STRUCTURAL PEER REVIEW STATEMENT

**Re: 250 South Street, New York, NY
Independent Structural Engineering Foundation Review
GMS Project Number 14299**

**INDEPENDENT FOUNDATION STRUCTURAL ENGINEERING
PEER REVIEW**

**250 SOUTH STREET
NEW YORK, NY**

Figure 1: Foundation ETABS Model

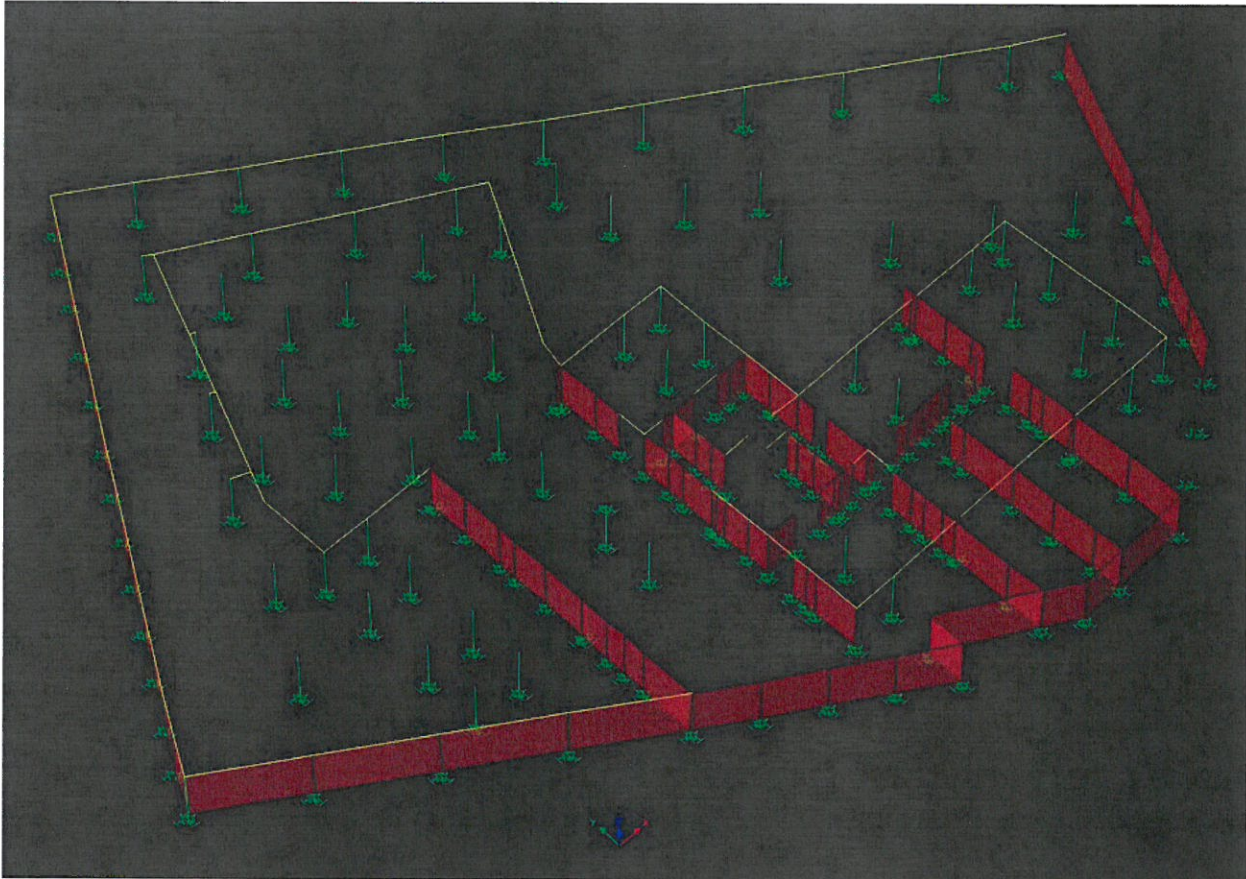
Analysis of the foundation piles & caissons was completed by utilizing the WSP ETABS model given to GMS dated 6/19/14. GMS verified the correct input wind loads, and the correct design assumptions within the model.
